Date	Expiration	Release	Page
02.2015	02.2017	1	1(3)

ALTERNATOR RETURN PULLEY TORQUE

Prevost vehicles

Figure 1

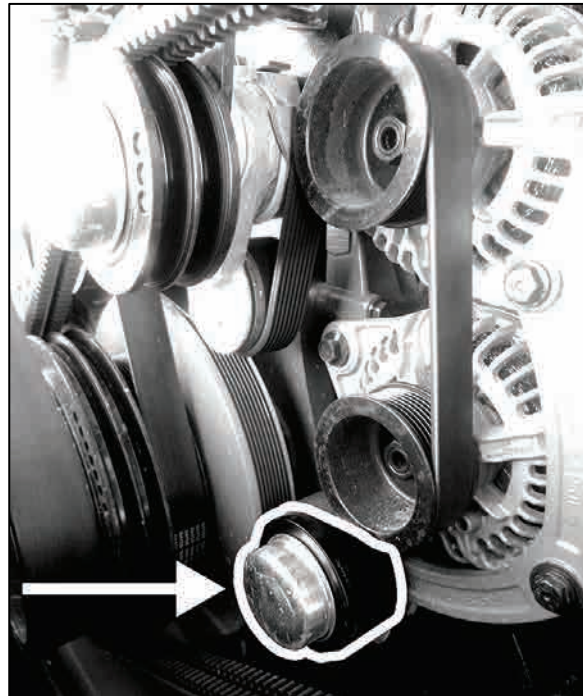
1. In the engine compartment, remove cap on alternator return pulley. (Fig. 1)
2. Remove bolt "A" apply blue loctite 680038 on bolt. (Fig. 2)
3. Tighten to 74 lbf-ft. (Fig. 2)
4. Re-install cap. (Fig. 1)

Figure 2

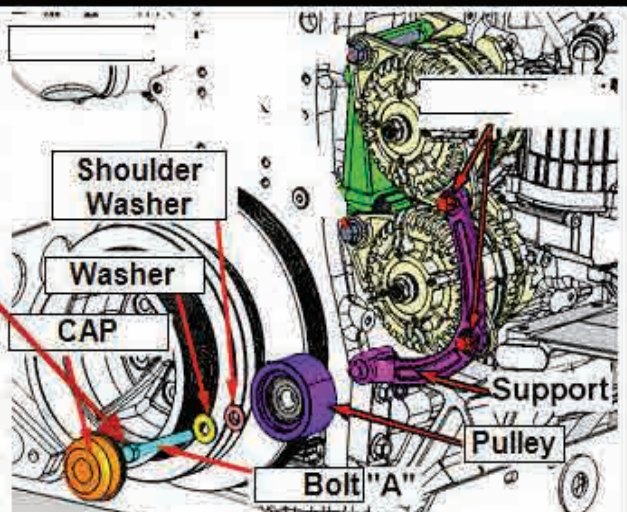
Large AC alternators			
10	Support assembly	21134692	qty 1
11	Return pulley	457705	qty 1
12	Shoulder washer	053690	qty 1
13	Washer	500211	qty 1
14	Blue Loctite 243	680038	
15	Bolt "A"	5001688	qty 1
	Torque bolt "A" (T62)	74 lb-ft	*0026*
		1x	
	Tensor-S - M3457		
16	Bolt "B"	5001801	qty 2
17	Nut "B"	5001930	qty 2
